Subject: Brunswick Steam Electric Plant, Unit Nos. 1 and 2
Renewed Facility Operating License Nos. DPR-71 and DPR-62
Docket Nos. 50-325 and 50-324
Response to Request for Additional Information Regarding Third 10-Year
Inservice Inspection Interval Request for Relief RR-46 (NRC TAC
Nos. ME1249 and ME1250)

Response to Request for Additional Information Regarding Third 10-Year Inservice Inspection Interval Request for Relief RR-46

10 CFR 50.55a Request Number RR-46

Attachment 1
(Supporting the Response to NRC Question 1)

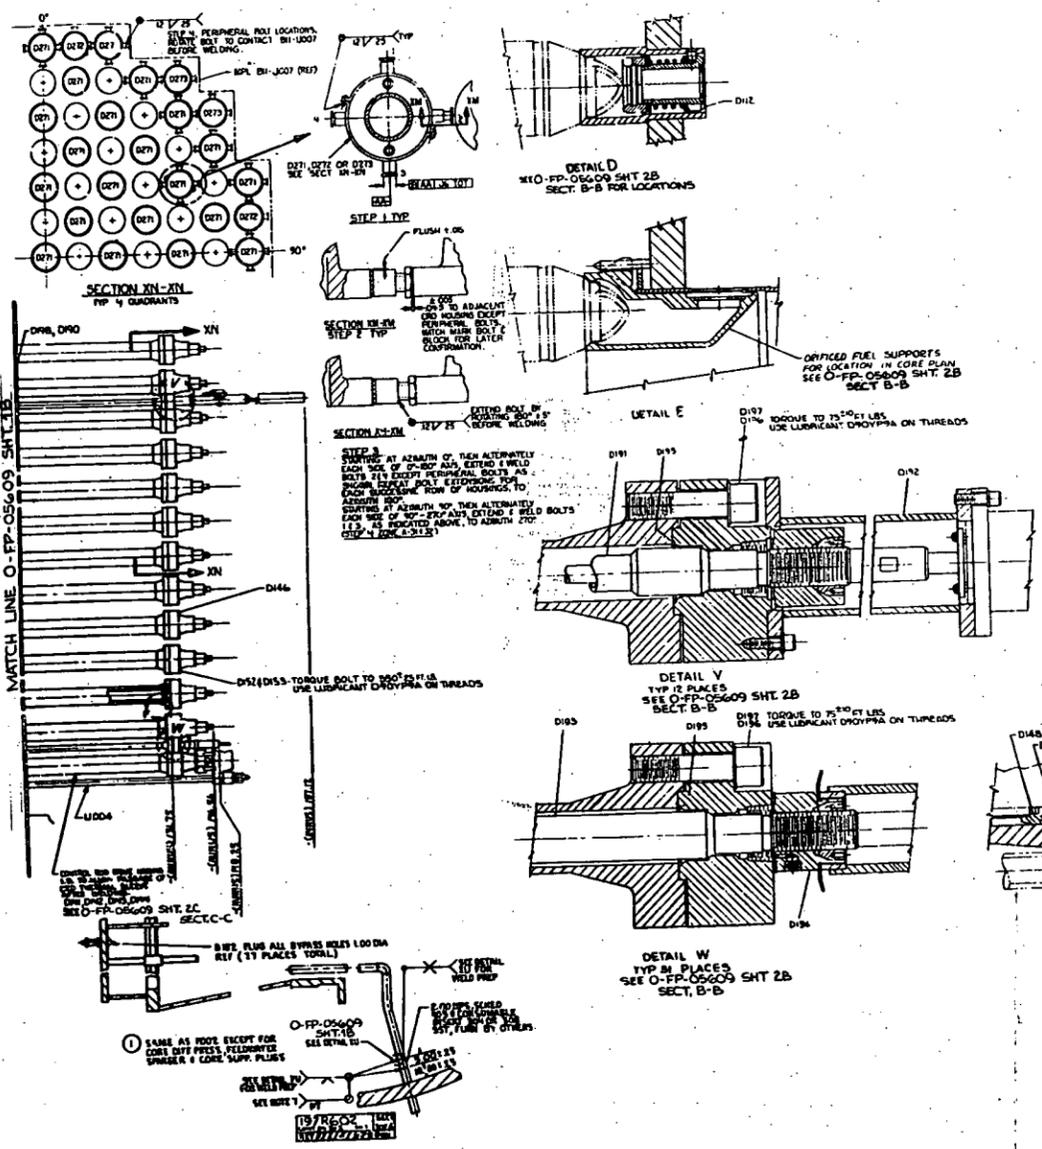
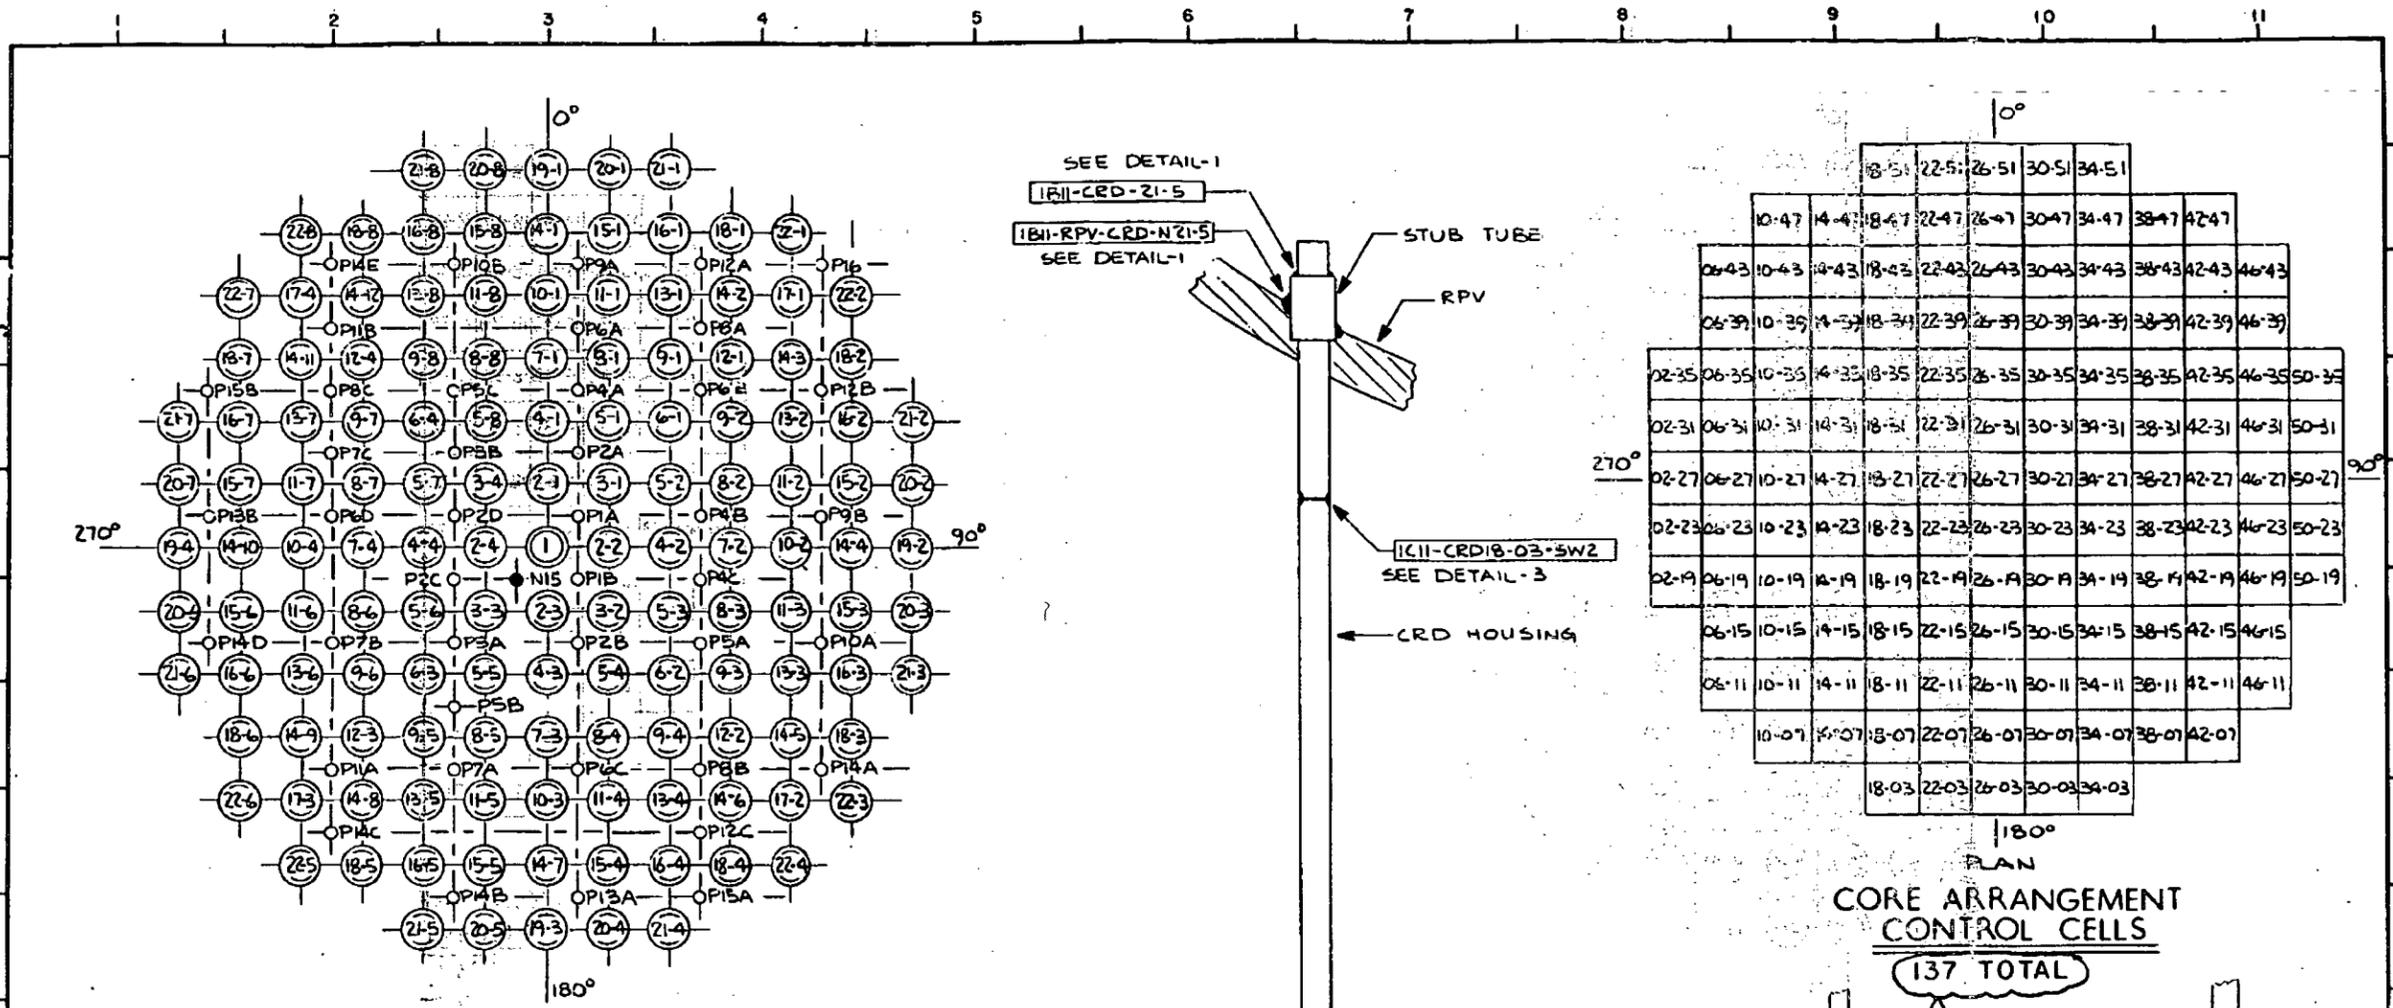
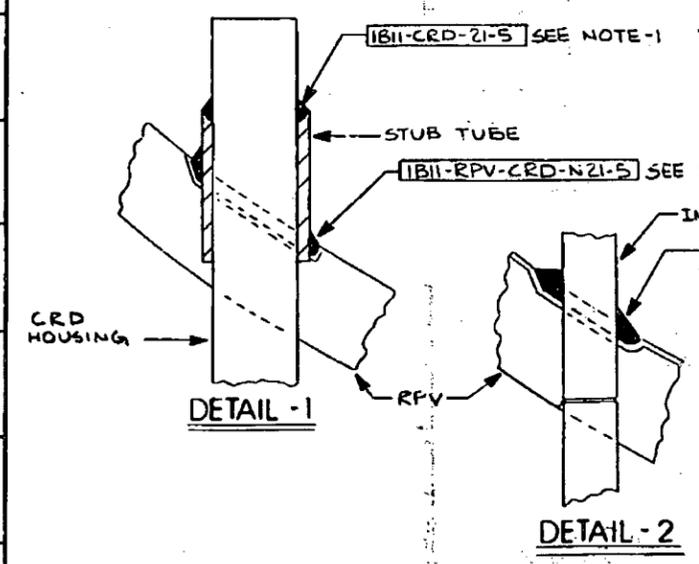
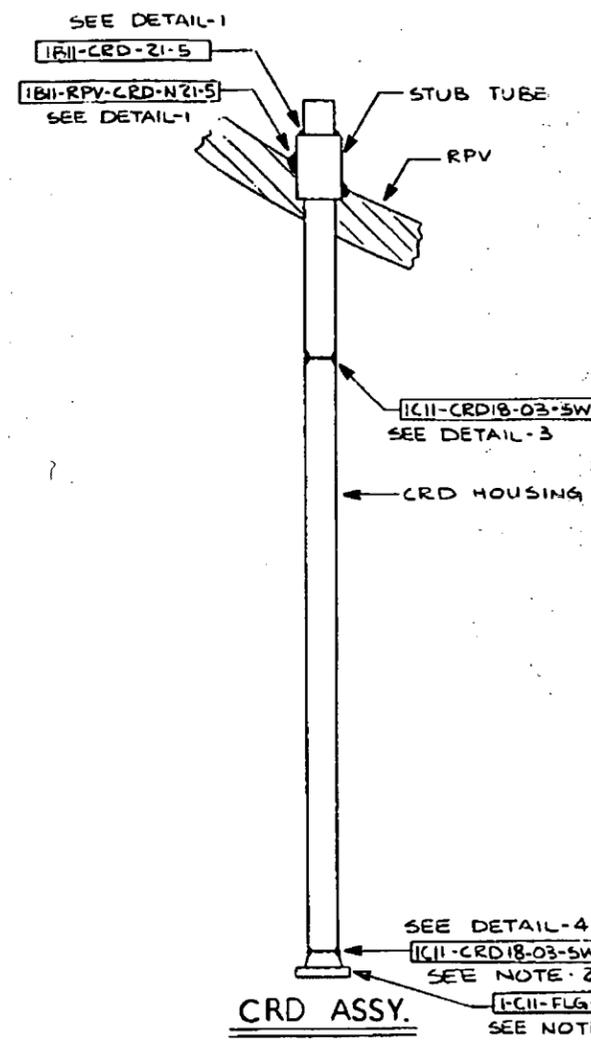
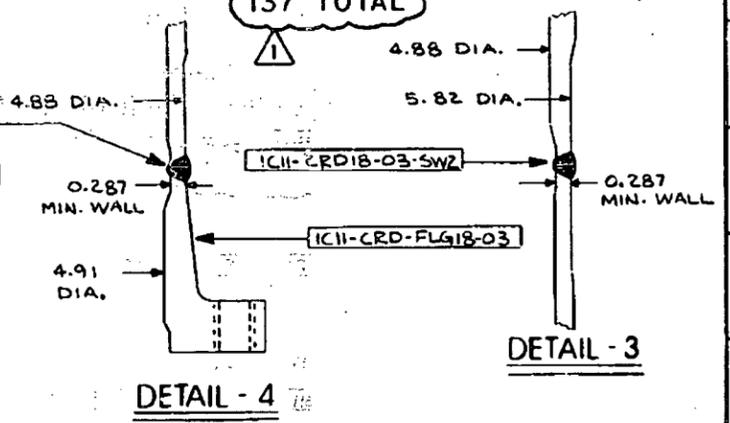
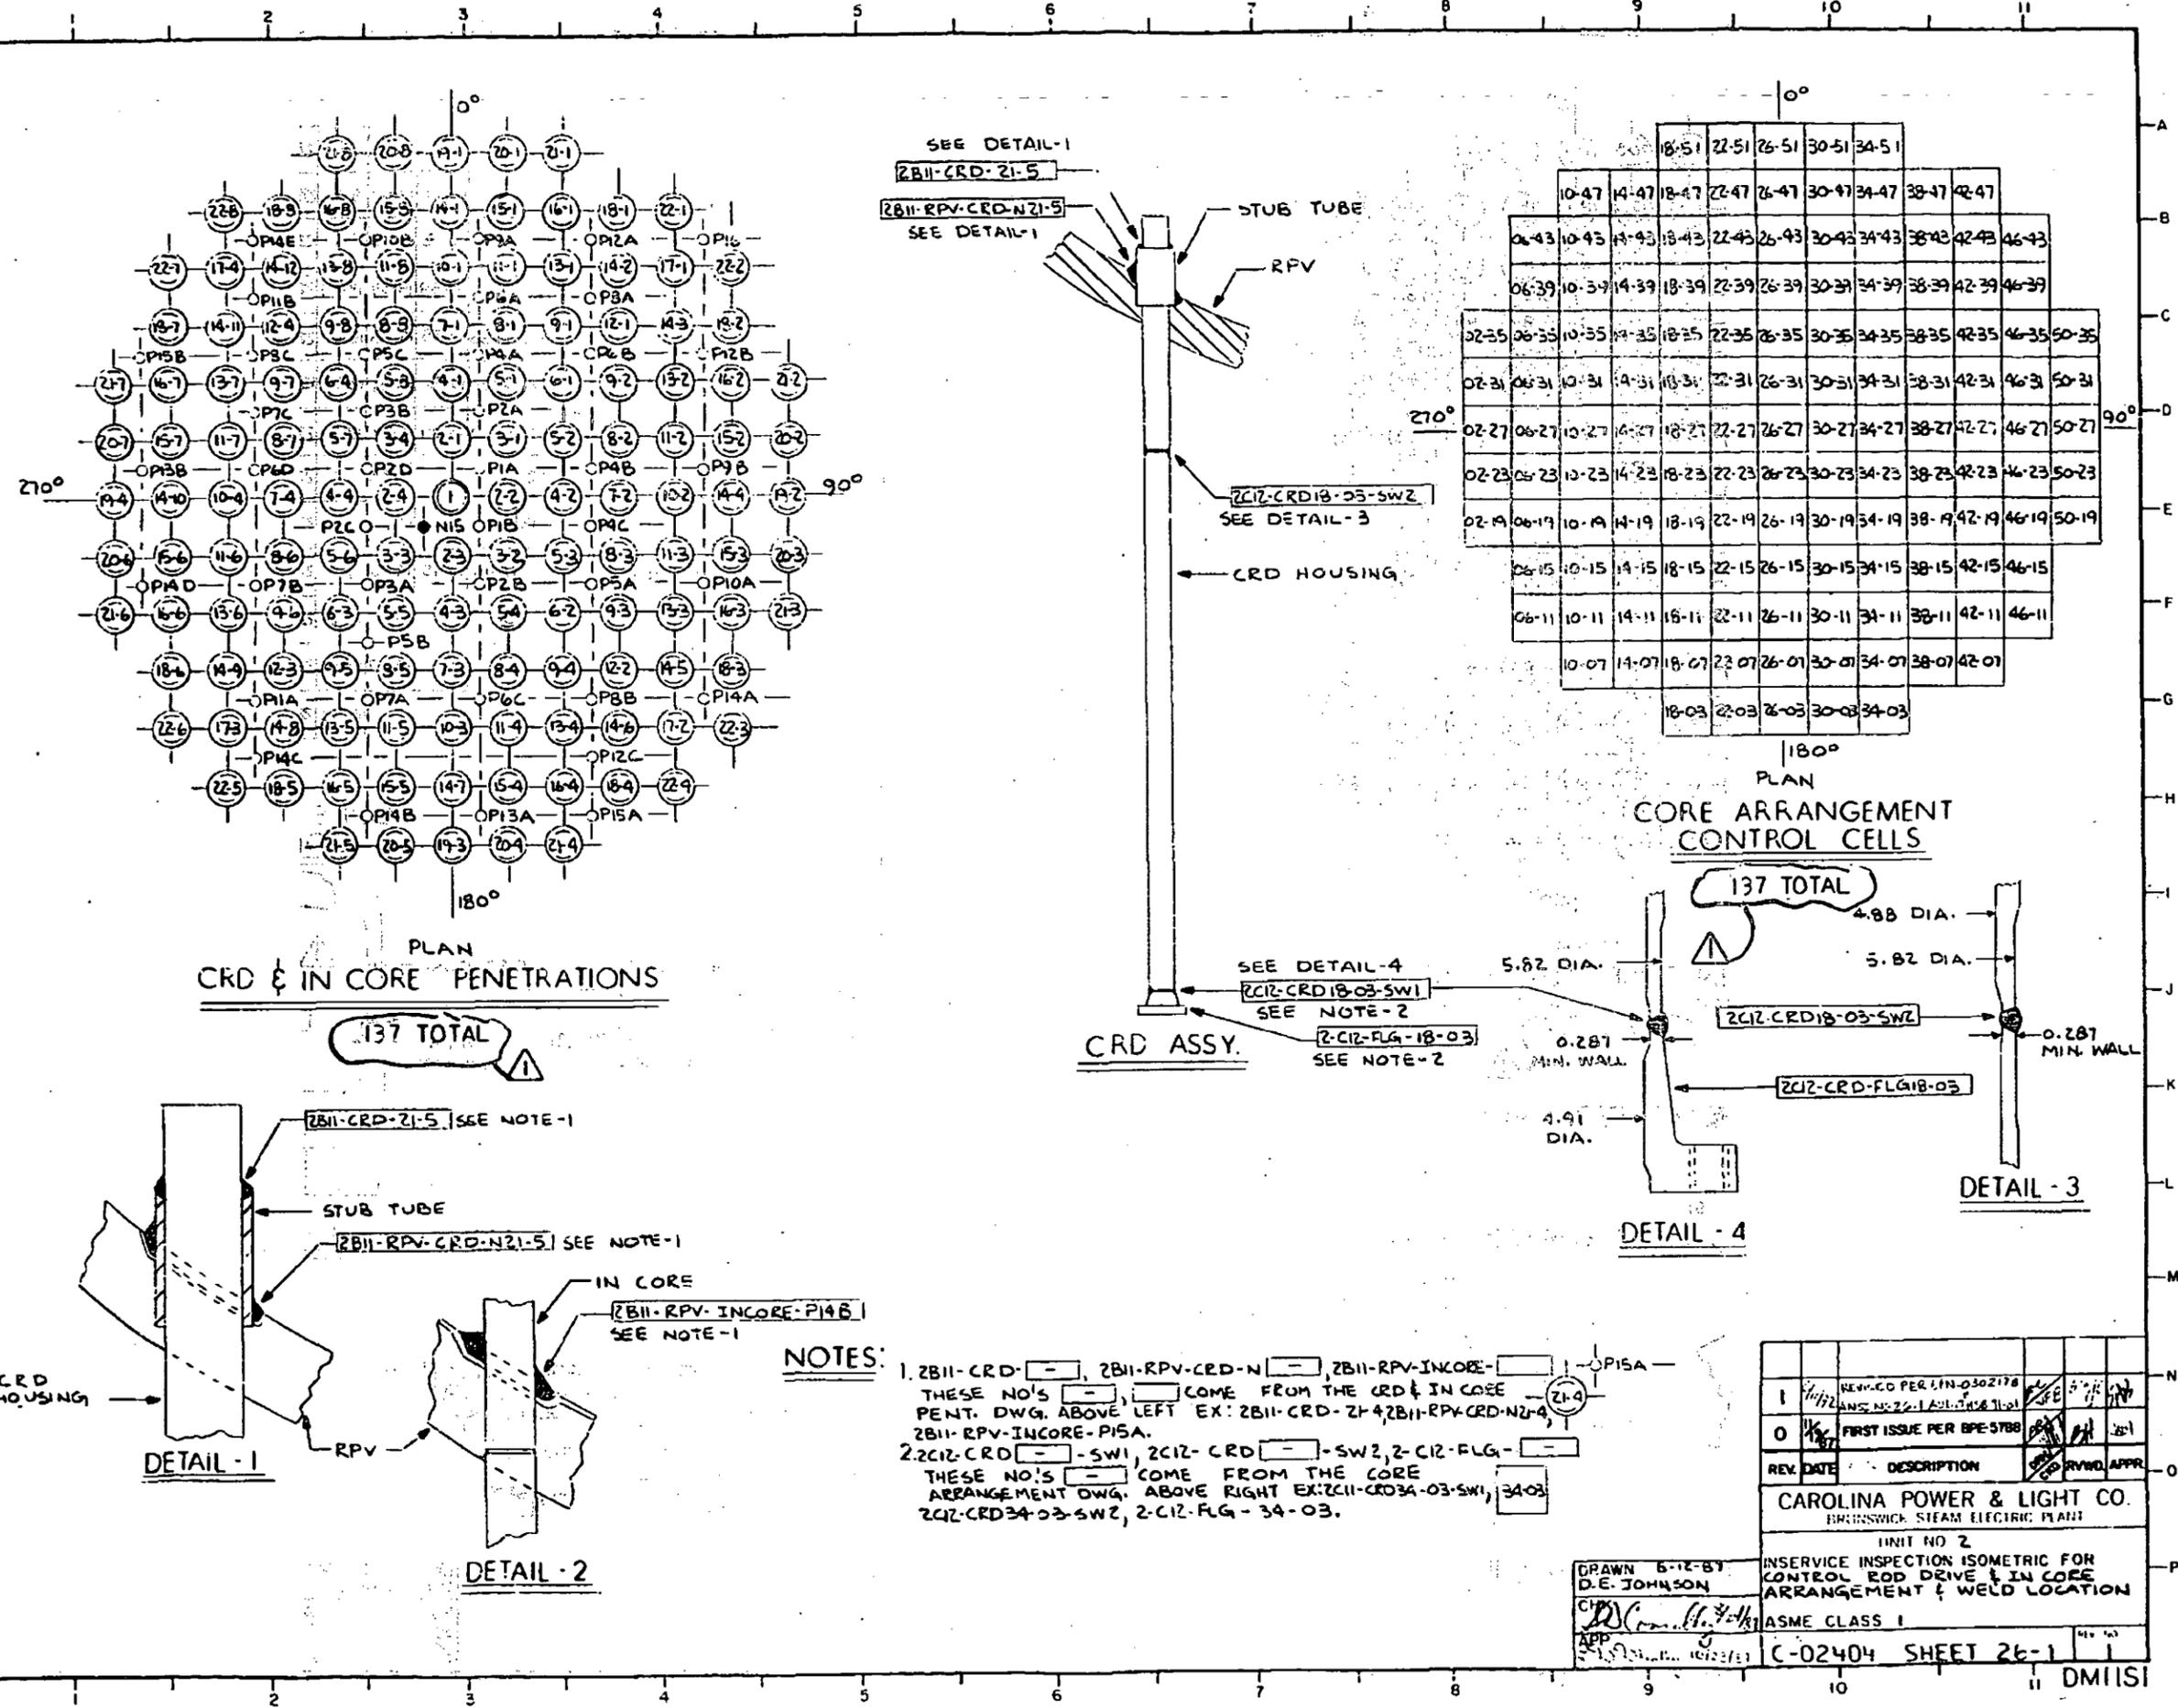
Provide copies of Attachments 1, 2, and 3 to Relief Request No. RR-46 which are more legible. If necessary provide enlarged copies of these Attachments.

Enlarged copies of the requested plant drawings, which were previously provided in Attachments 1, 2, and 3 CP&L's letter dated May 8, 2009, are provided in Attachment 1.

Attachment 2
(Supporting the Response to NRC Question 2)

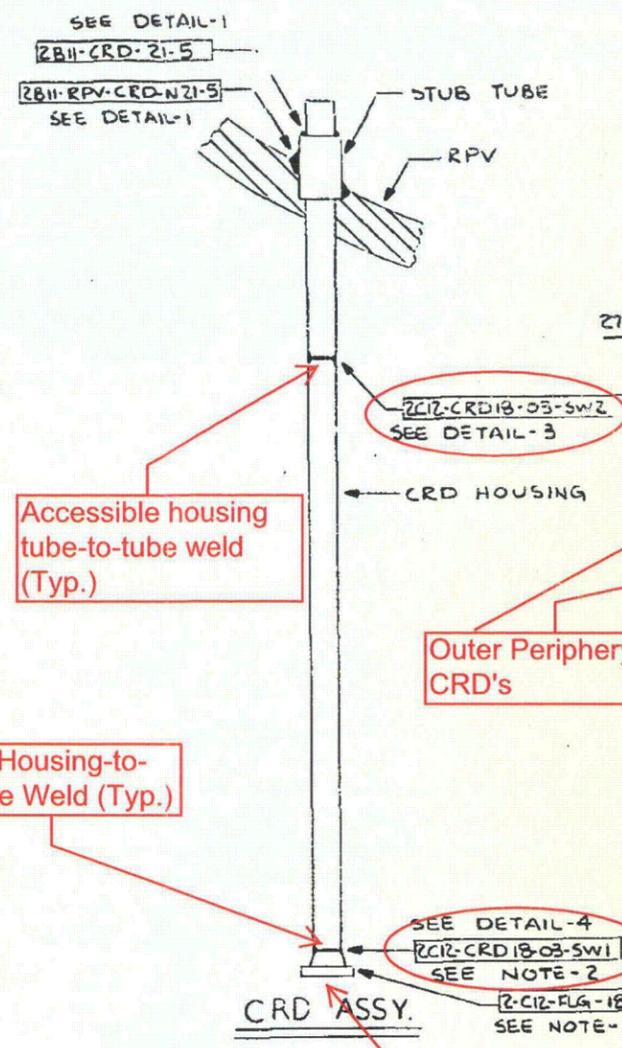
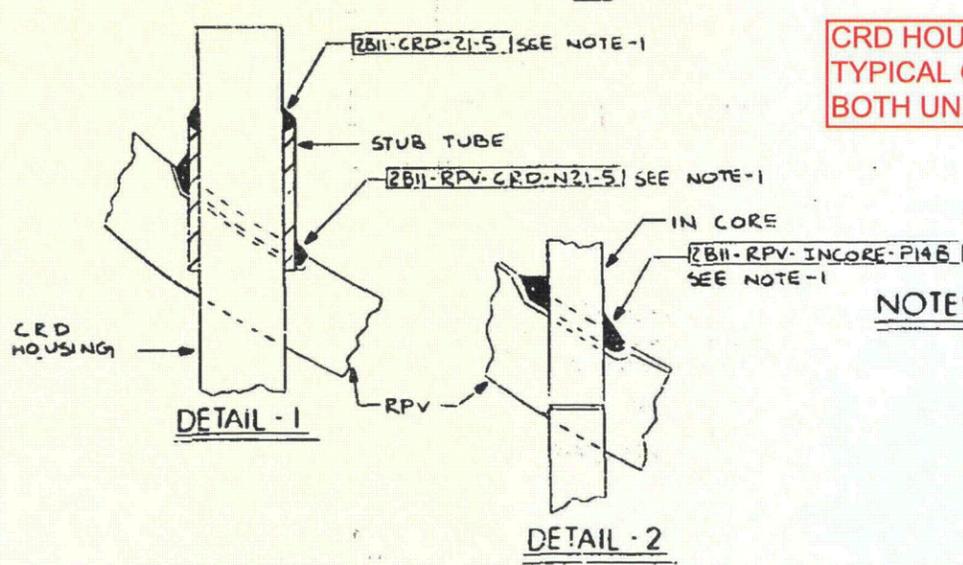
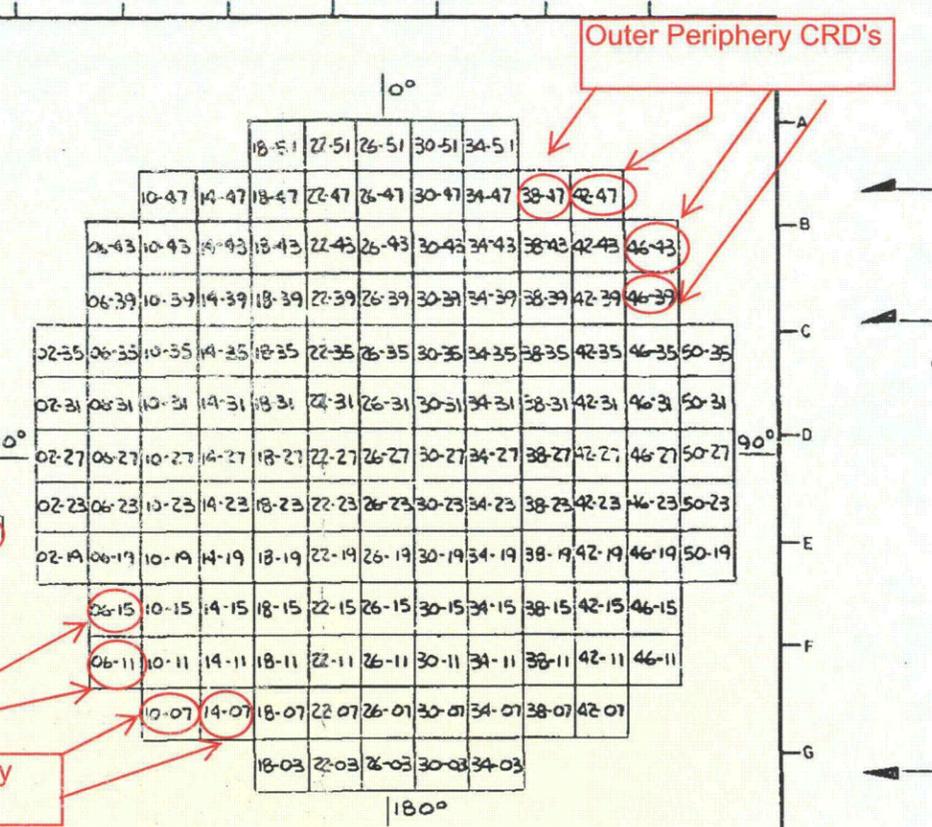
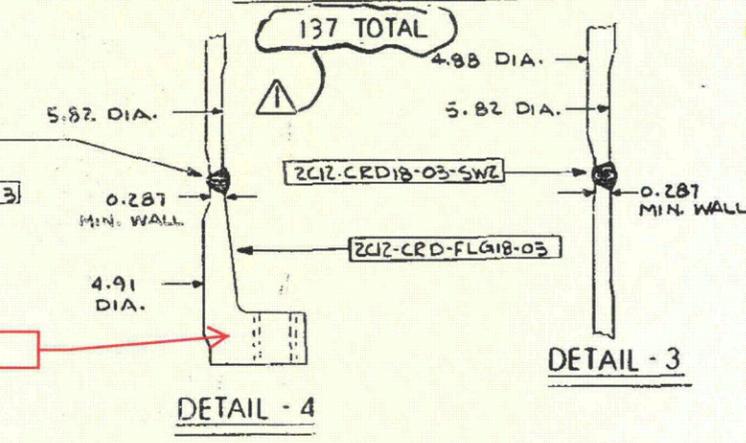
On Attachments 2 and 3 to Relief Request No. RR-46, indicate, i.e., circle, all of the relevant (control rod drive) CRD housings.

The drawings provided in Attachments 2 and 3 were functionally equivalent, with Attachment 2 being a Unit 1 drawing and Attachment 3 being a Unit 2 drawing. As a result, only the drawing previously provided in Attachment 3 of CP&L's letter dated May 8, 2009, has been annotated to indicate the relevant CRD housing features. The annotated figure is provided in Attachment 2.

CRD HOUSINGS
TYPICAL OF
BOTH UNITS
